**NOTICE OF AVAILABILITY OF A  
REVISED FINAL ENVIRONMENTAL IMPACT REPORT  
AND NOTICE OF INTENT TO CERTIFY AN ENVIRONMENTAL IMPACT REPORT**

**Project Title:** Pacific Gas and Electric Company (PG&E) Line 406-407 Natural Gas Pipeline

**Revised Final Environmental Impact Report  
for PG&E Line 406/407 Natural Gas Pipeline Project  
Yolo County, Sacramento County, Sutter County, and  
Placer County, California  
State Clearinghouse No. 2007062091  
California State Lands Commission EIR No. 740**

Figure 2-10  
10-Inch DFM Construction ROW Configuration

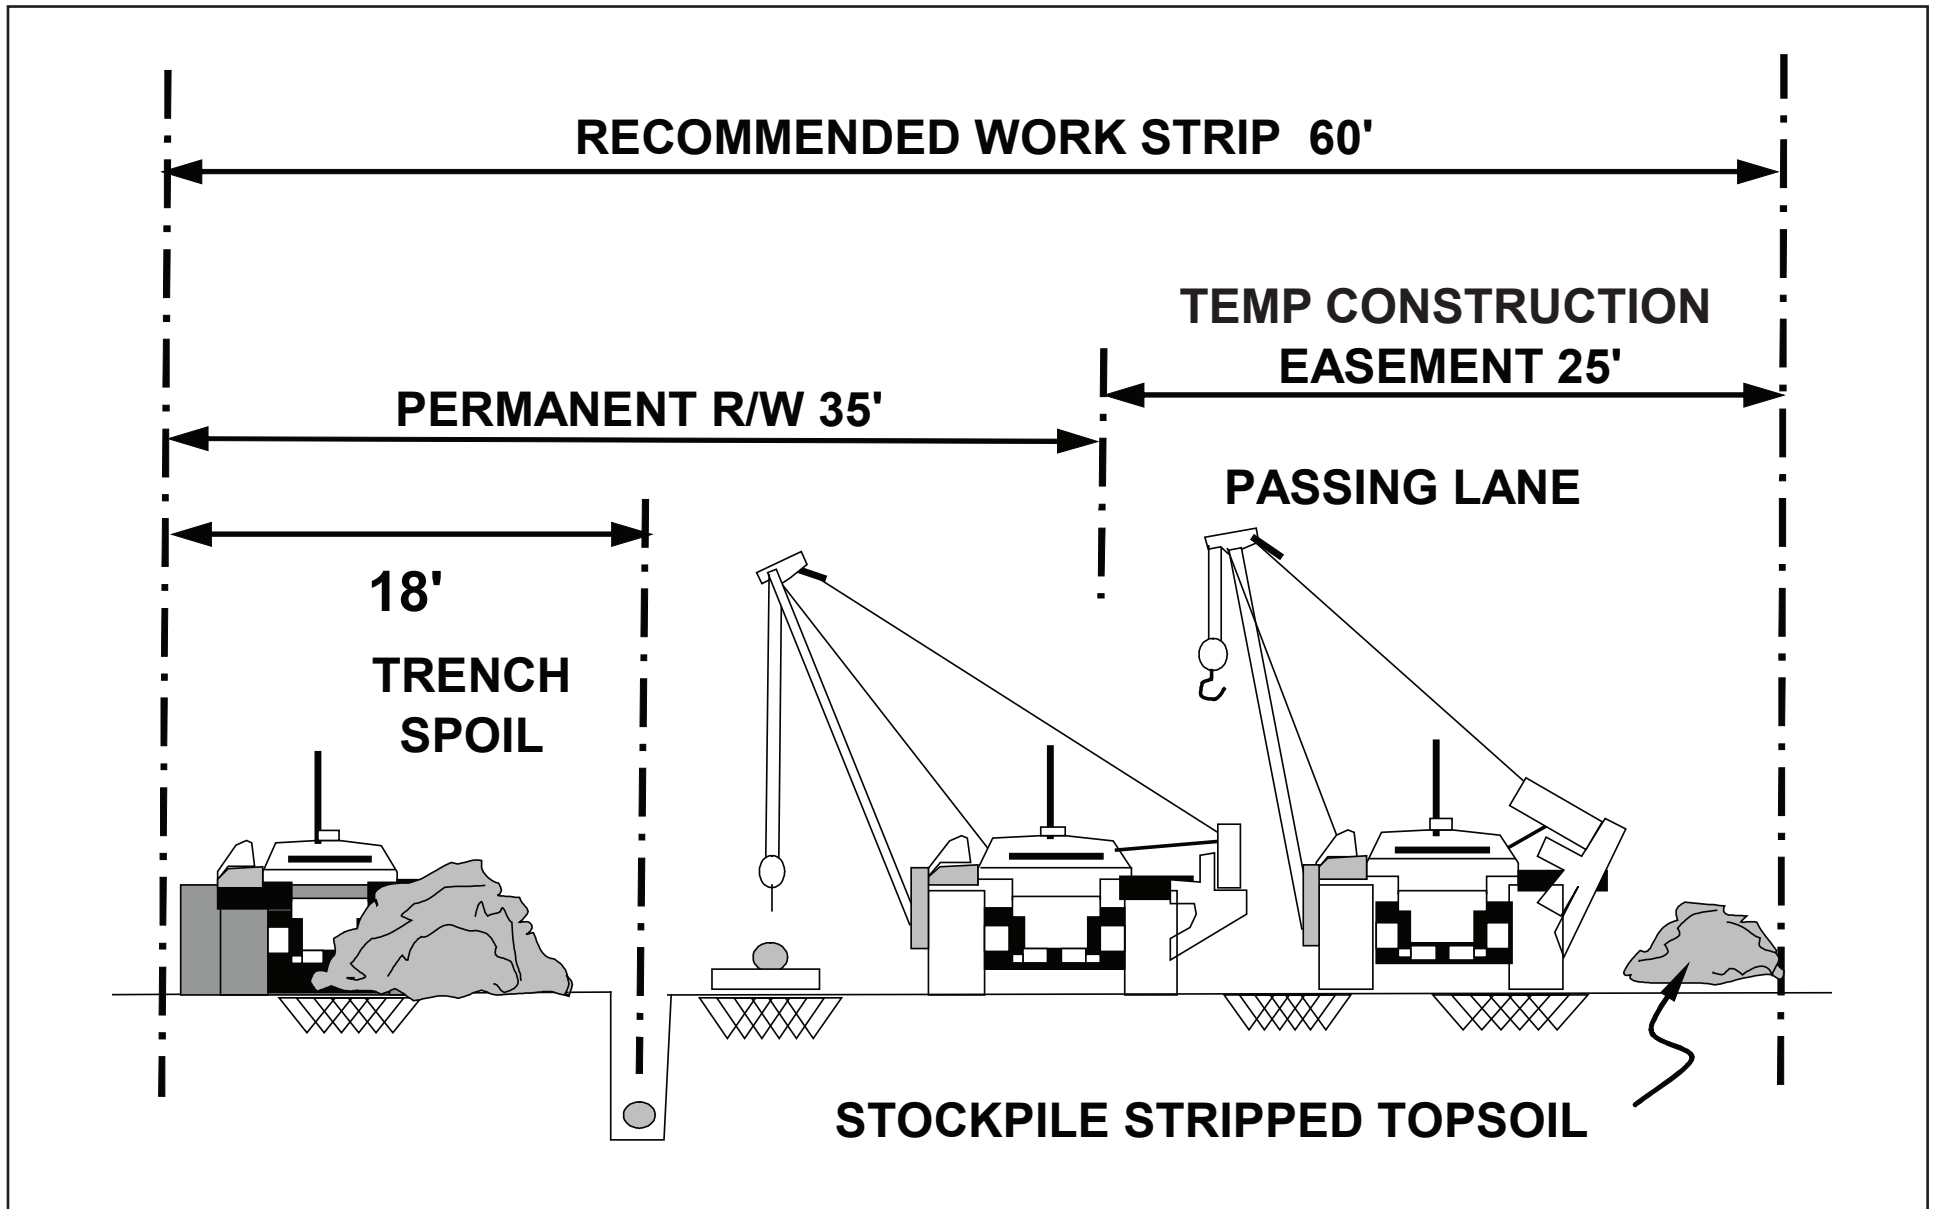
In addition, Figure 2-9 should be labeled as the configuration for the 30-inch pipeline construction right-of-way. Figure 2-10 should be labeled as the configuration for the 10-inch DFM pipeline construction right-of-way.

23 **S-13** Comment acknowledged. Page 2-37, line 1 through 3, of the Draft EIR  
24 has been revised. Figure 2-9 and Figure 2-10 have been relabeled. Refer to  
25 Section 4.0 of this Revised Final EIR for revisions to the Draft EIR.

- 23 **2-39** Please see revised Figure 2-10 on page 4-43-44 of this section.
- 24 **2-49** Also, PG&E would hold a preconstruction meetings with ~~between~~  
 25 permitting entities and ~~the~~ construction crews.
